The Mills Building

1700 Pennsylvania Avenue, NW
Washington DC

Modification before the Board of Zoning
Adjustment

Board of Zoning Adjustment
District of Columbia
CASE NO. 2019-0003
EXHIBIT NO. 3B

Floor Plan Diagram - Level 10 to Level 11 (16,013 GSF/ Level)

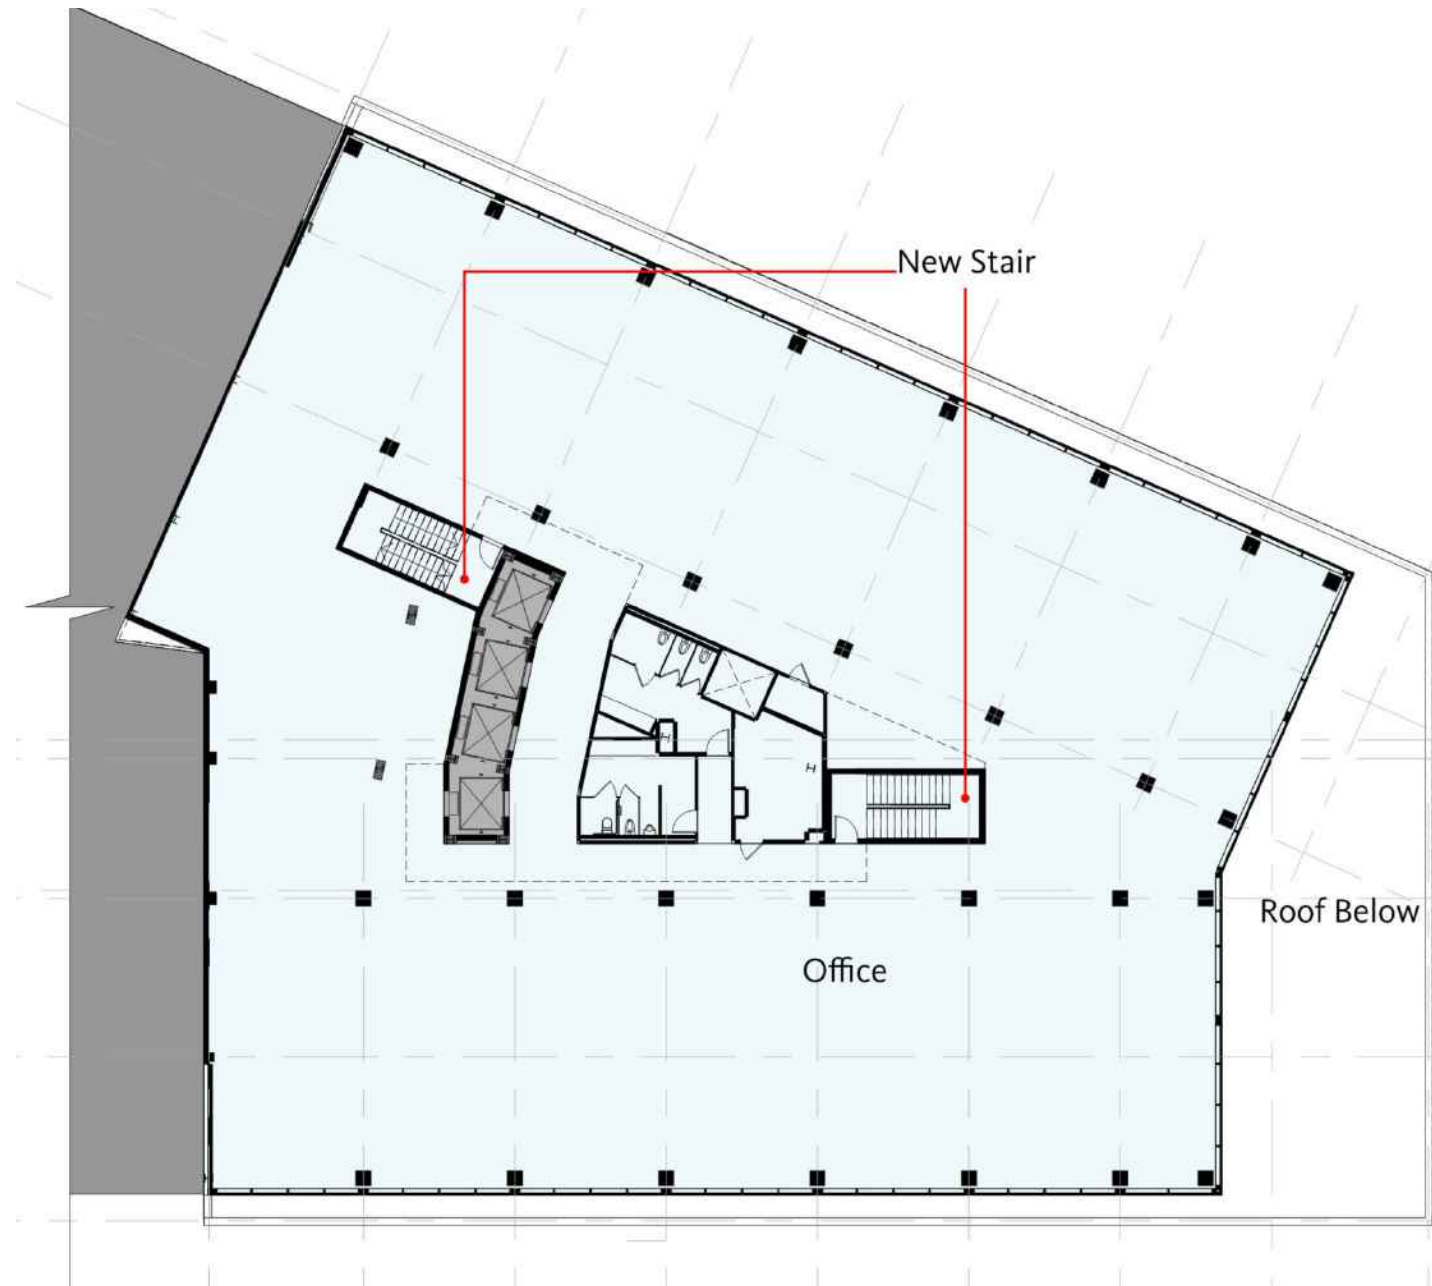
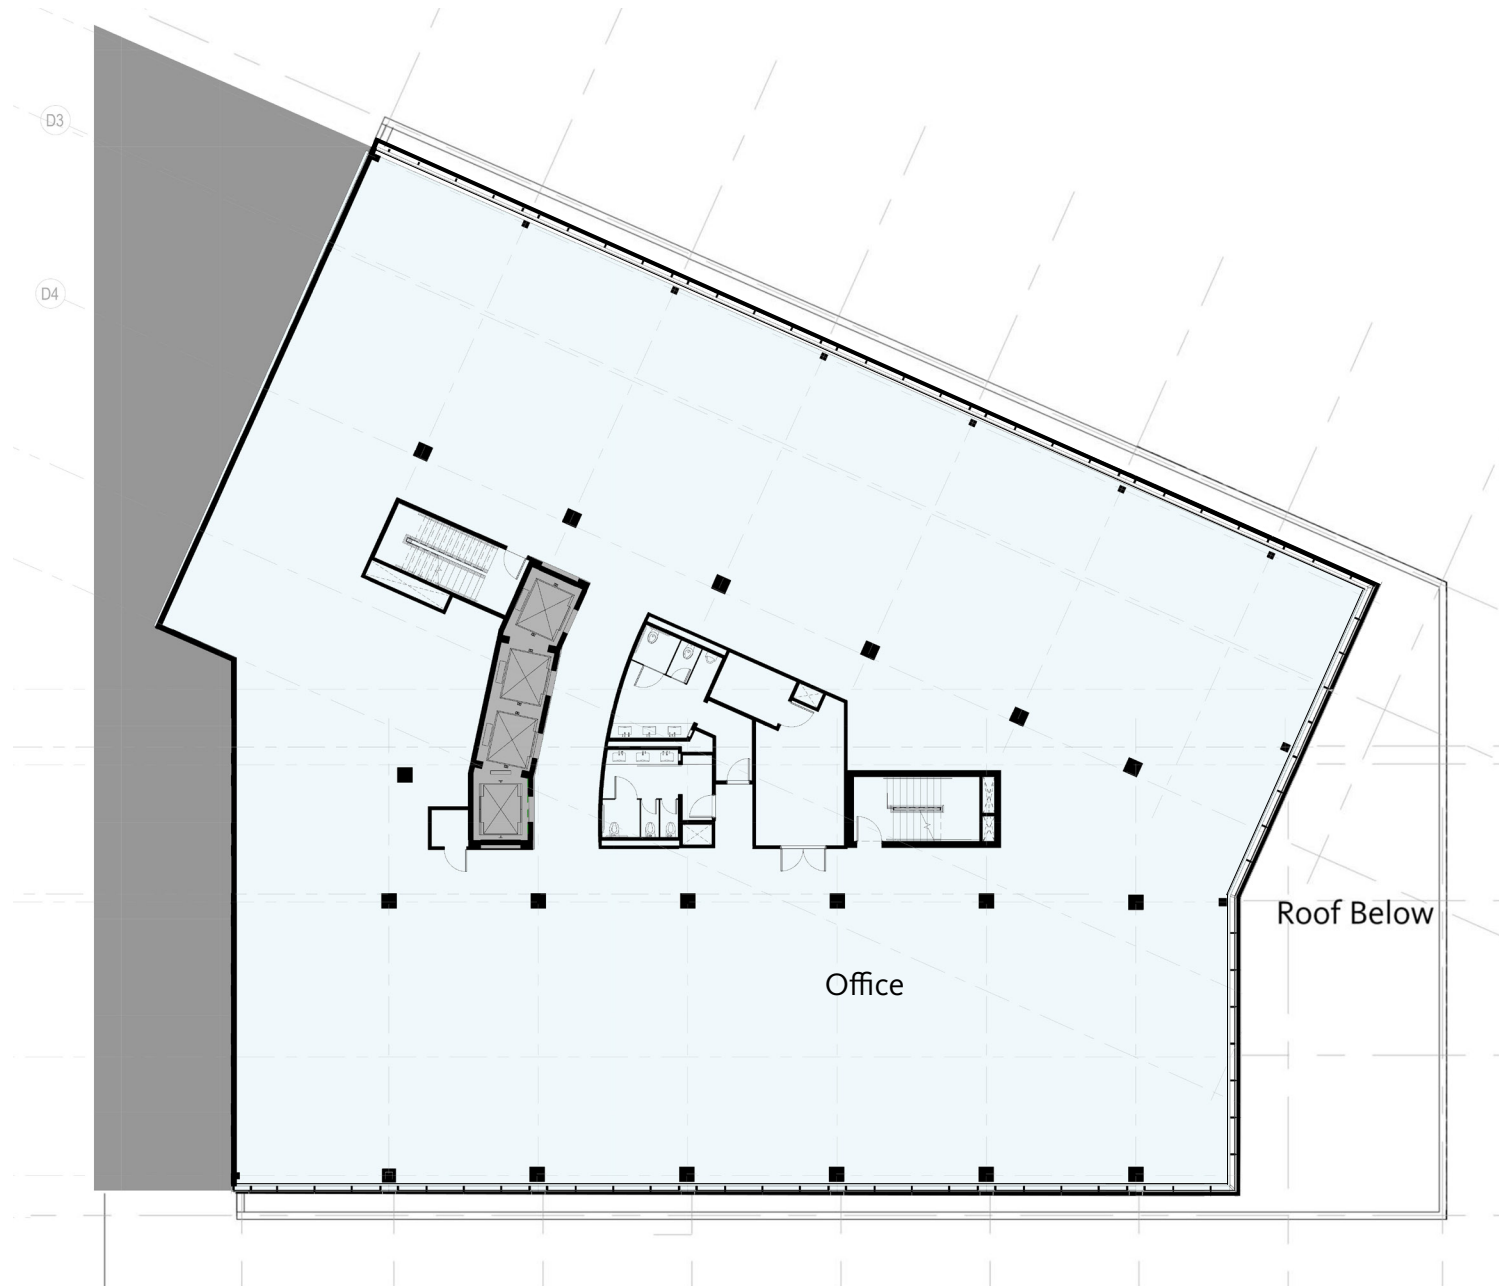
Exterior Revisions limited to facade treatments to satisfy CFA commentary.

Interior revisions limited to minor changes to core layout to accommodate existing utility services to remain, new services, and ADA.

Floor Plan Diagram - Penthouse Approved

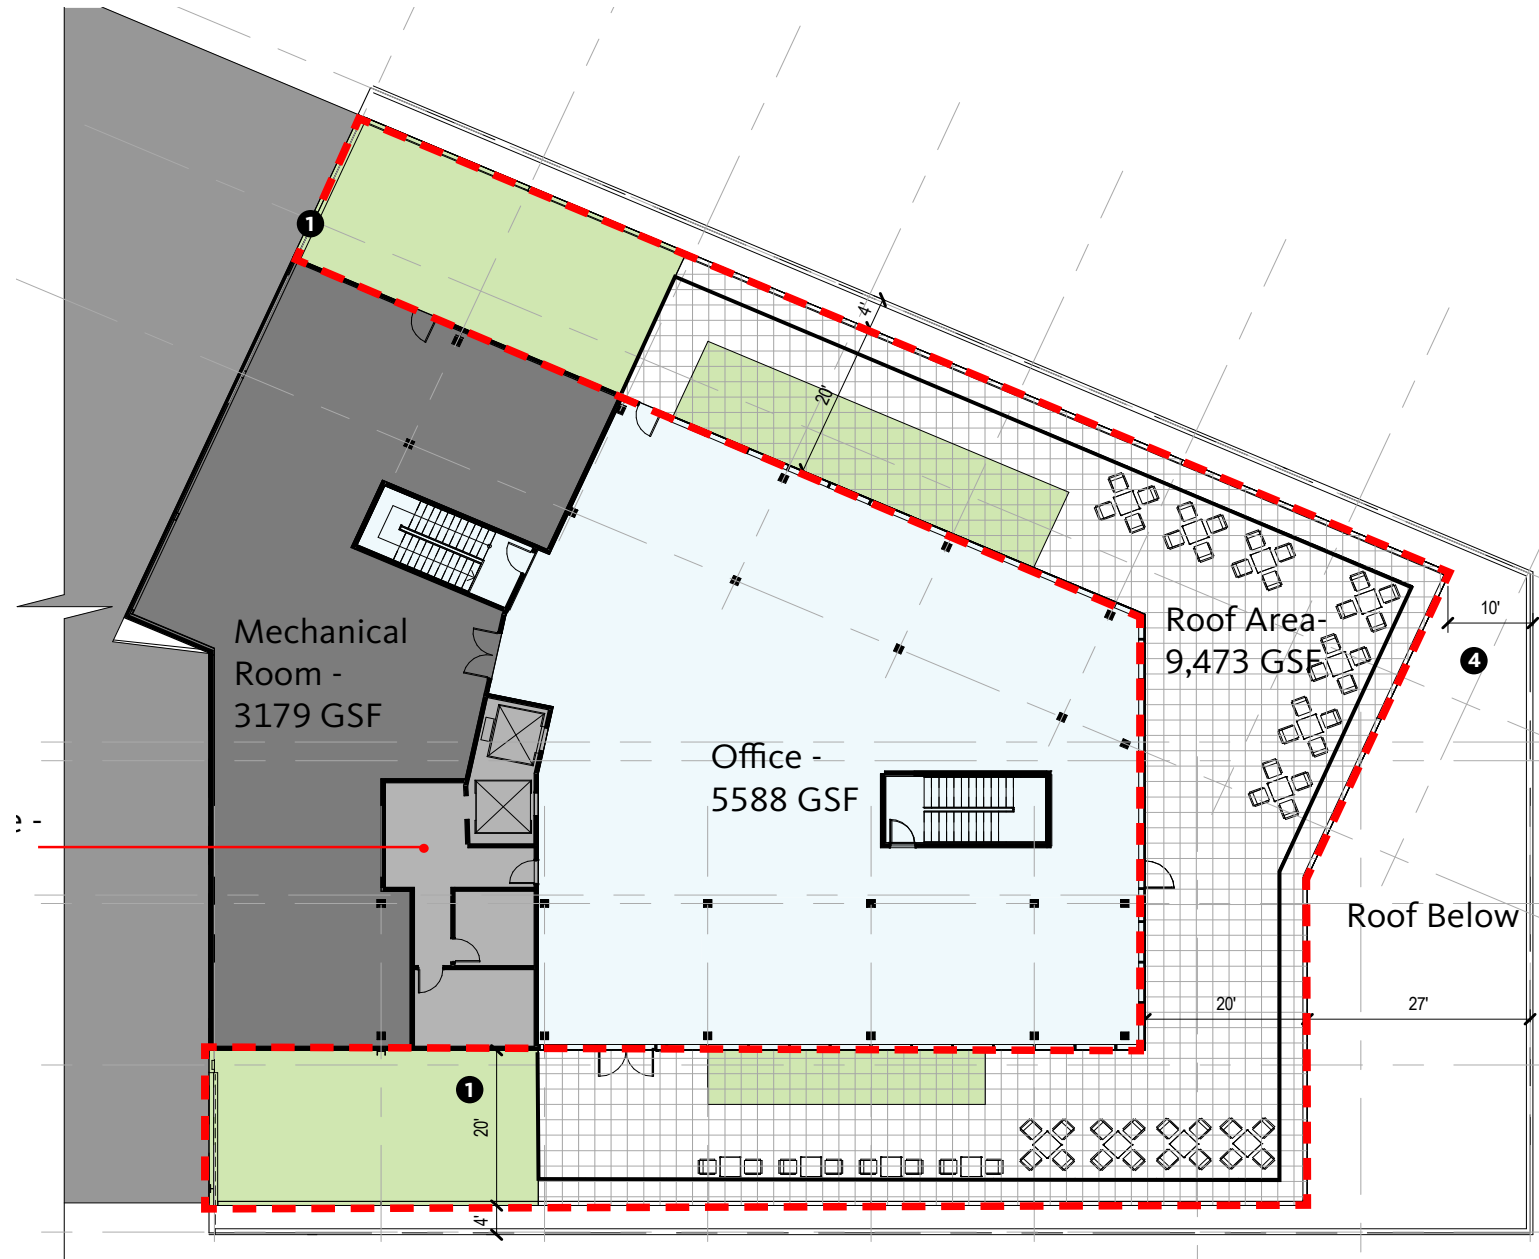
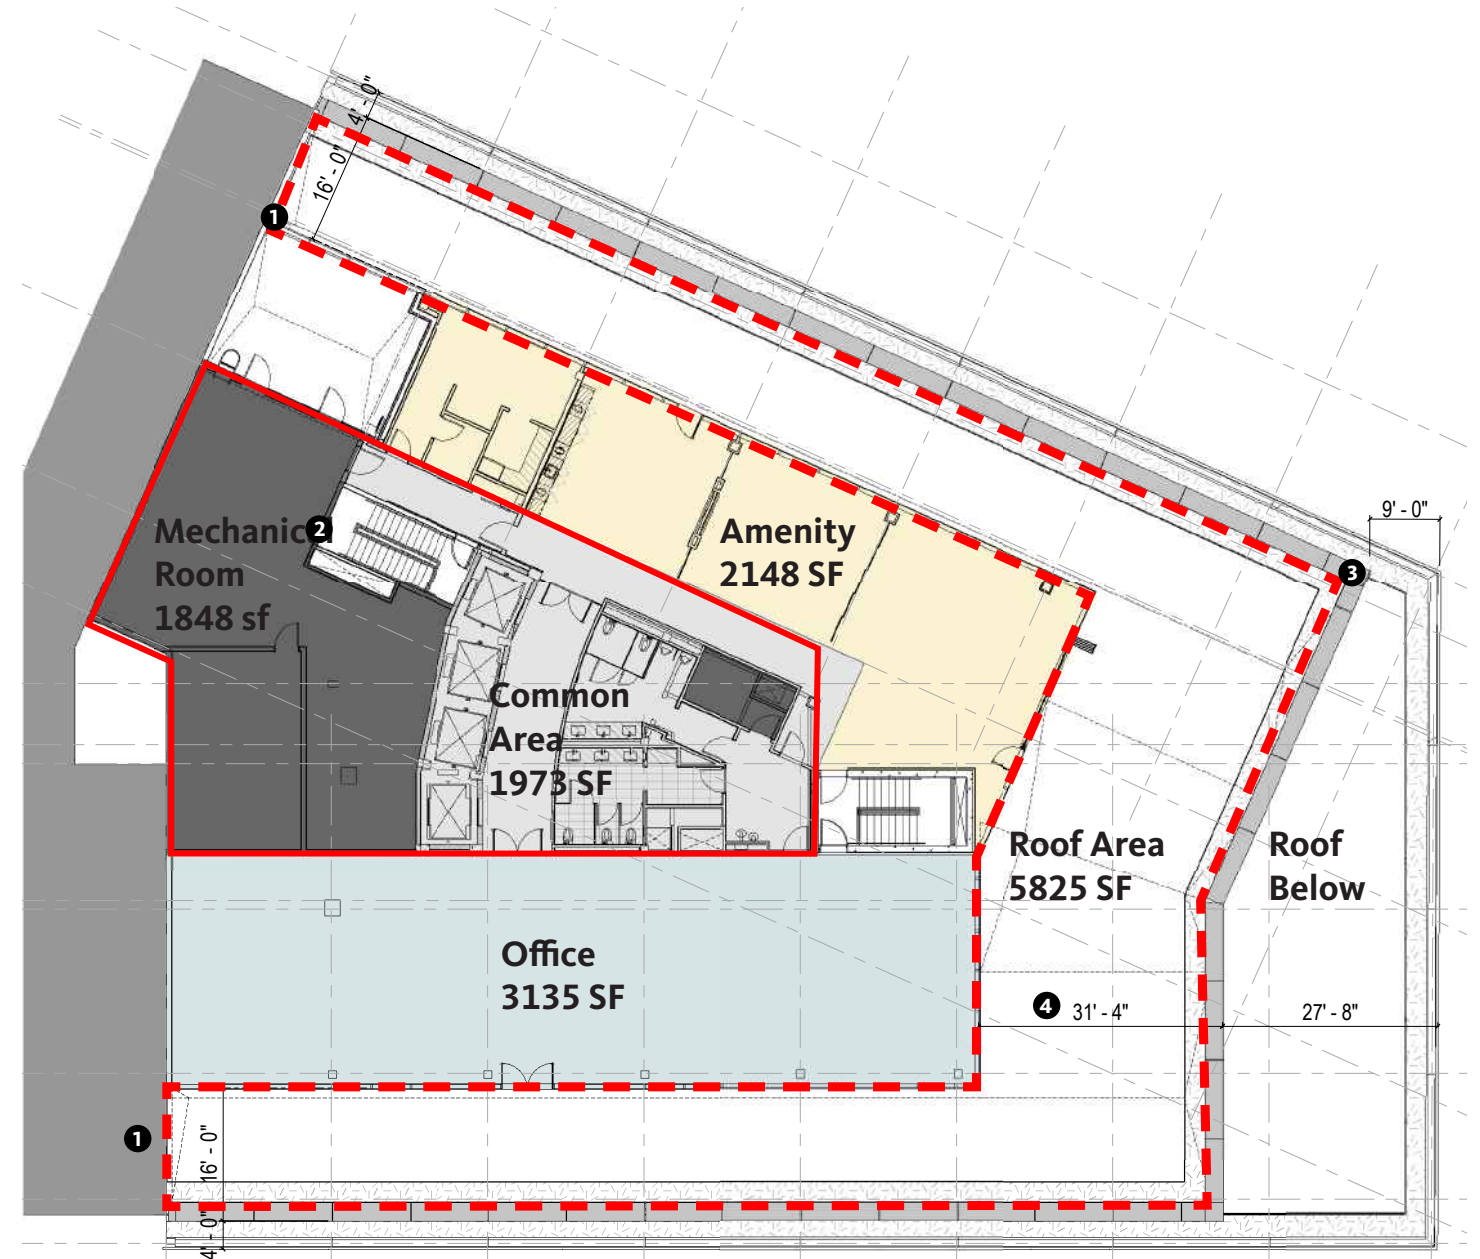
- 1 - Setbacks reduced slightly and penthouse enclosure stepped accordingly to meet 1:1 setback
- 2 - Previous design provided a height of 20' for the entire penthouse; revised design proposes a height of 16' for the perimeter amenity and office areas, with a height of 20' for the interior mechanical and common areas.
- 3 - Setback of outdoor terrace reduced by 1'.
- 4 - Butterfly form introduced at east end and setback dimensions increased

Layout adjusted to accommodate more detailed program requirements and MEP coordination.
